May 7, 1986

Corporation Falconbridge Copper
6415 64th St.
Delta, B.C.
V4K 4E2

Memo re: Borehole Survey Mt. Sicker, Hole # MTS5

SECTION C-D "QUESTIONABLE" CONDUCTOR LOCATION

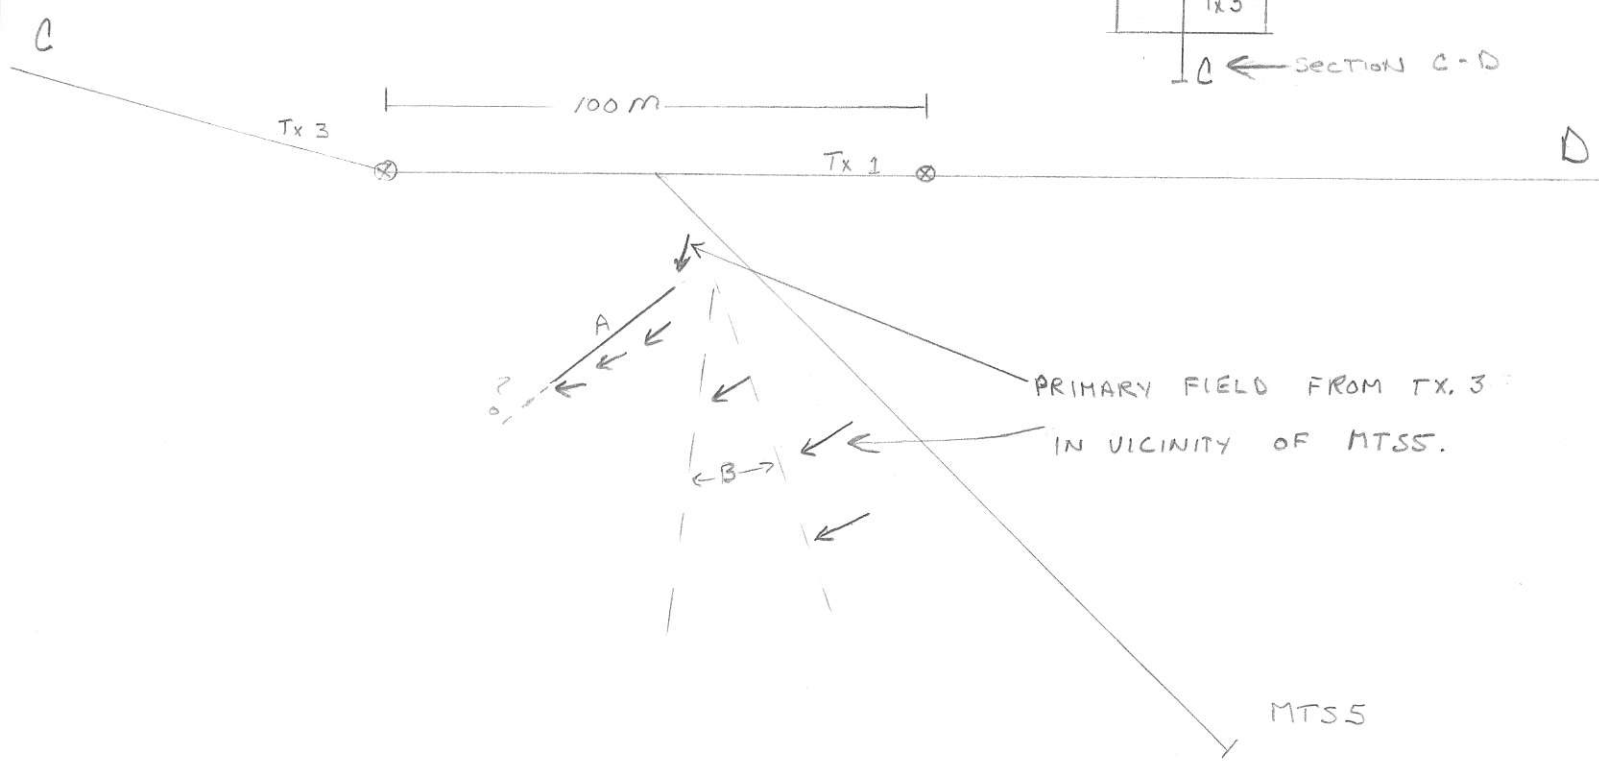
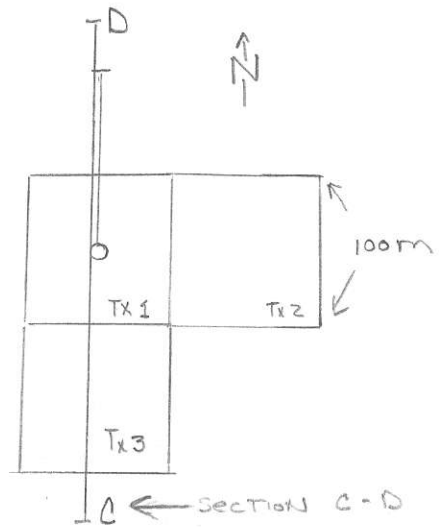
The erratic changes in the primary field strength measurement (see hole MTS5, loop 2) appear abnormal. This measurement is usually disregarded in an angled hole because of the coupling problem between the primary field and the receiver probe. Regardless, changes in the field should be fairly uniform unless the hole is in the immediate vicinity of a conductor.

The only significant anomaly in MTS5 is detected from transmit loop 1. The anomaly spans the full length of the hole with the strongest response at the collar of the hole. It can be interpreted as a cross-over response (conductor below & parallel to the hole, dipping at 70-90 degrees north) or as an off hole anomaly with the conductor near surface (within 20 meters) and dipping south (see attached figure). If the conductor was parallel or subparallel to the hole a response should have been detected from loop 3. If it was near surface and dipping south it should also have been detected from loop 3 unless it has a limited down dip extent (10-15m) and is paper thin. A positive to negative cross-over was detected when the hole was surveyed from Tx 2. This is likely related to the polarity problems discussed above and not an off hole conductor.

- A - SMALL CONDUCTOR DIPPING SOUTH COULD BE NULL COUPLED TO PRIMARY FIELD FROM TX. 3. CONDUCTOR WOULD HAVE TO BE THIN.
- B - CONDUCTOR SUB-PARALLELING MTSS DIPPING @ 70-90° N. CONDUCTOR SHOULD HAVE BEEN MAXIMUM COUPLED TO PRIMARY FIELD FROM TX 3!

In conclusion, the data is at best suspect. Therefore prior to drill testing the "anomaly" detected in MTSS repeat the survey of the hole. If the collar loop data is verified, survey all other loops (N,S,E,W) to assist in the interpretation of the conductor location.
